Service Bulletin

Design Update for Packing Assemblies (All Models 791 and 891)

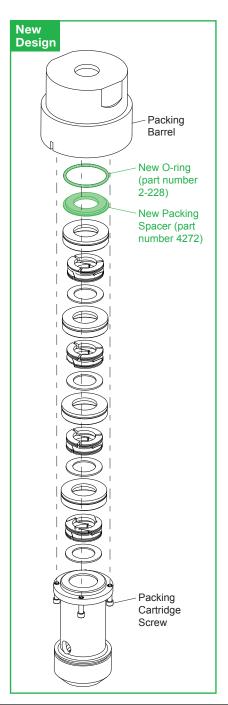
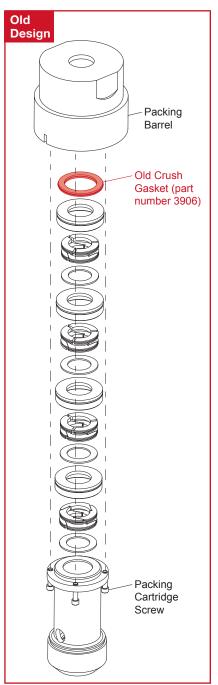
As part of Corken's continuous improvement efforts, a change in design was made to the packing assemblies for compressor models 791 and 891. Effective immediately, the crush gasket (part number 3906) is no longer used on all compressor models 791 and 891. Beginning with serial number 92084SL, the crush gasket has been replaced with a machined packing spacer (p.n. 4272) and O-ring (p.n. 2-228). The purpose for this change is to eliminate alignment issues between the packing cartridge and packing barrel. When using the crush gasket, if the four mounting screws (p.n. 7002-025OC100A) are not torqued evenly, the packing cartridge will not align properly with the packing barrel causing the packing set to leak prematurely. With the new design, all four screws now have a hard stop so it's much easier to achieve a centered alignment each time.

This change impacts all packing specifications (i.e. J, K, R, G, H, and F) for models D791, D891, FD891, T791, T891, and FT891. The following drawings show the differences between the new and old design.
